DEPARTMENT OF THE ARMY
BUFFALO DISTRICT, CORPS OF ENGINEERS
1776 NIAGARA STREET
BUFFALO, NEW YORK 14207

SUBJECT: R.E. GINNA Nuclear Generating Plant, Town of Ontario, NY

PURPOSE OF REPORT

2. This letter report presents the results, conclusions, and recommendations arising from inspections of the engineering and operational aspects of the existing stone revetment along the lakeshore on Lake Ontario at the R.E. GINNA Nuclear Generating Plant.

PLATE 1

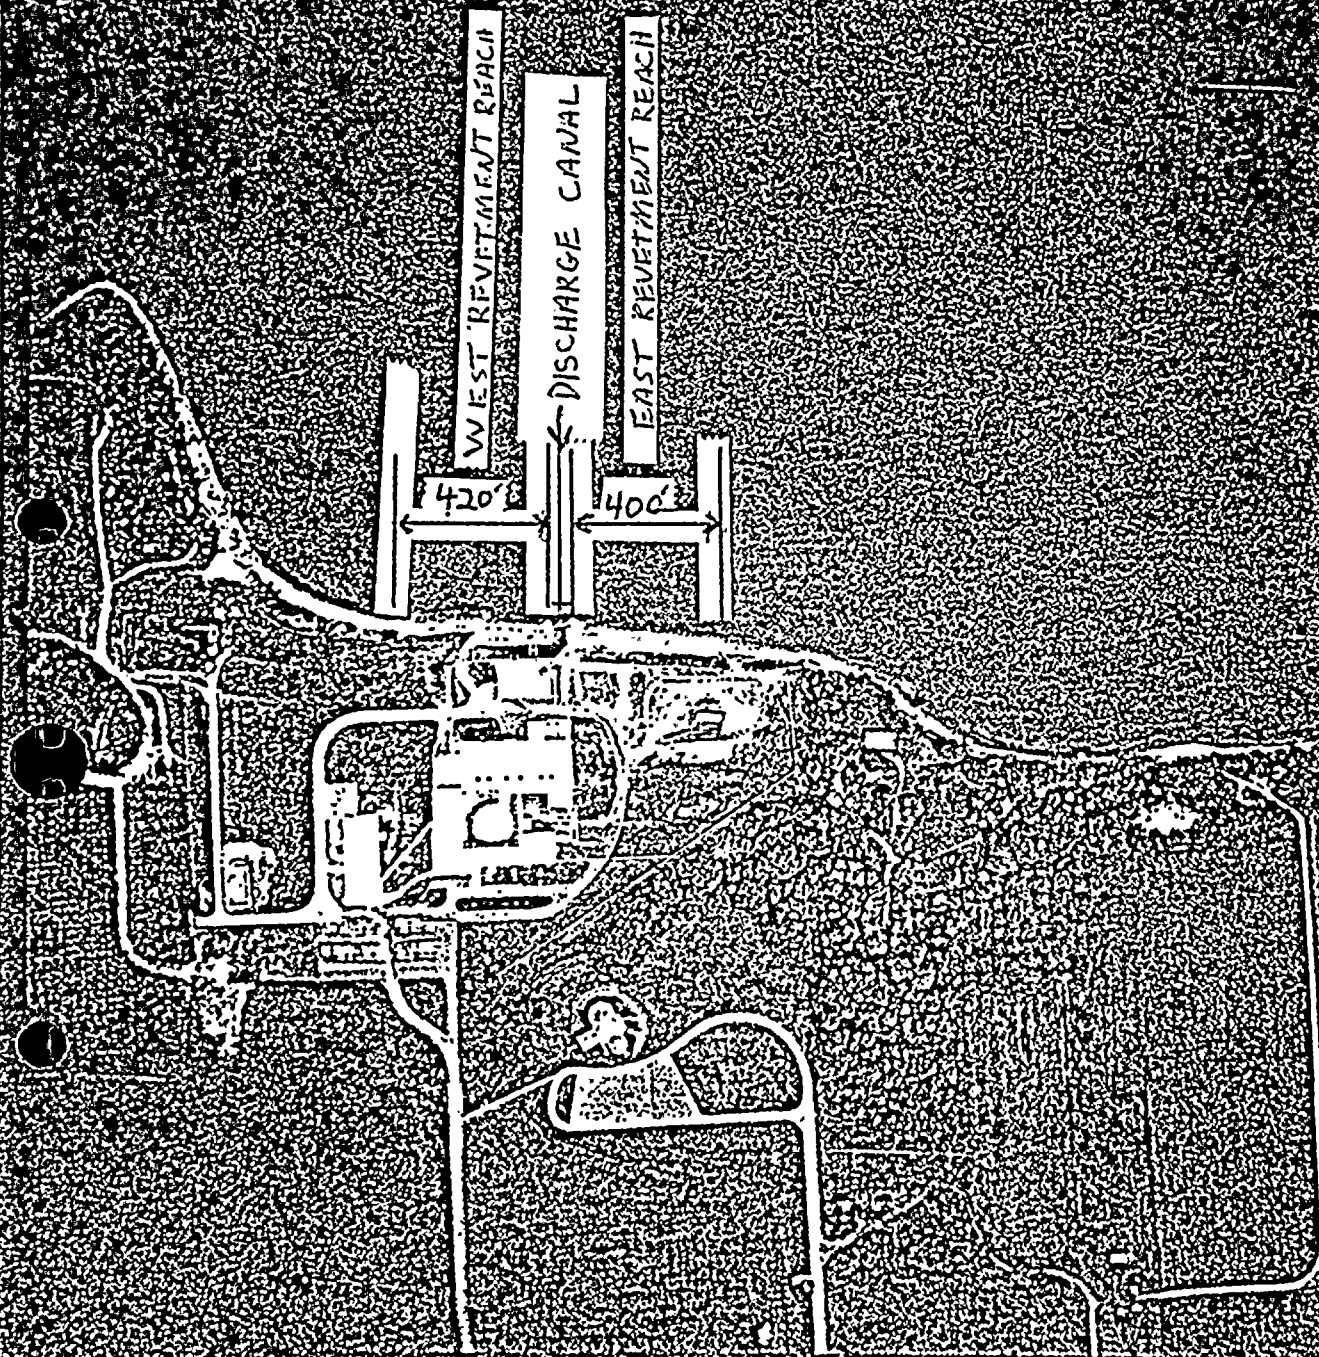
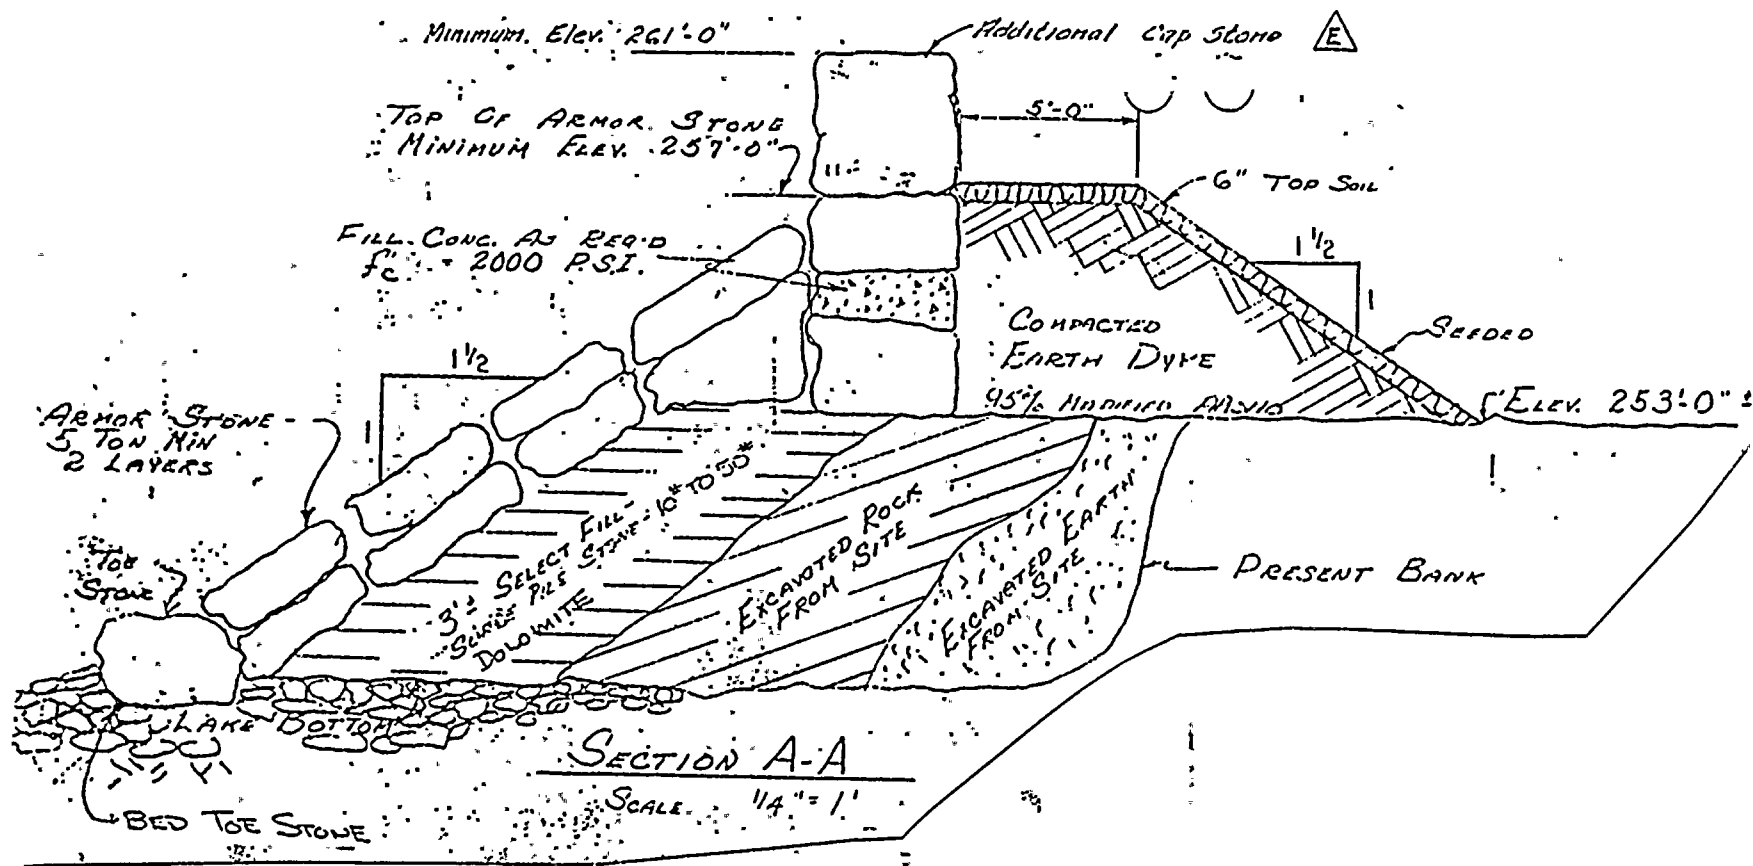
6. The stone revetment was constructed in two reaches: an estimated 420-foot long west reach and an estimated 400-foot long east reach. The east and west stone revetment reaches are separated by a 20-foot wide discharge canal from the generating plant (see Plates 1 and 2). According to Section A-A and Section B-B on Drawing No. 33013-51E Reference 1f), the stone revetment was initially constructed in the 1960's with two layers of 5-ton minimum armor stones laid up on a 1.0 vertical on 1.5 horizontal sideslope to a minimum elevation of 257.0 (msl). Due to the high lake levels that were predicted for Lake Ontario during the early 1970's, the crest elevation of the revetment was raised to a minimum of 261.0 (msl) by placement of cap stone along the top of the revetment. Typical cross-sections of the east and west reaches of the stone revetment are shown on Plates 3 and 4.

TYPICAL SECTION - EAST REVETMENT REACH

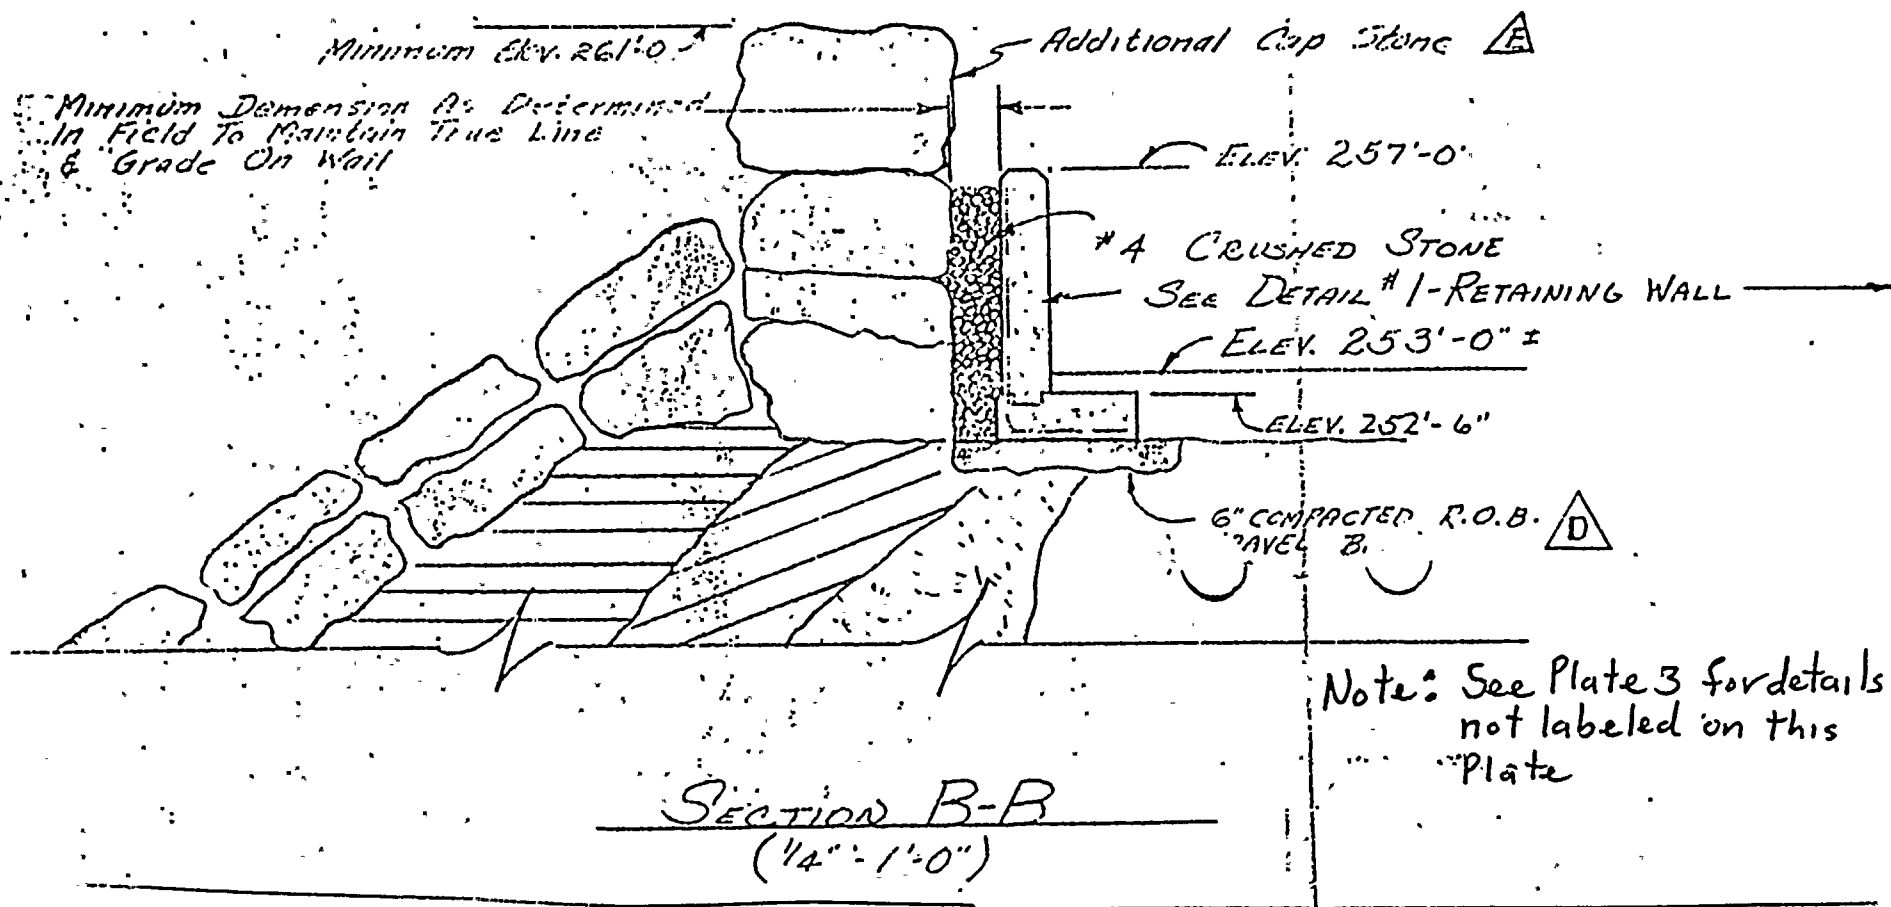
18. The east side of the revetment is in excellent condition, however, the large void should be filled with concrete or large enough stone such that they will not pass through the voids in the armor layer.
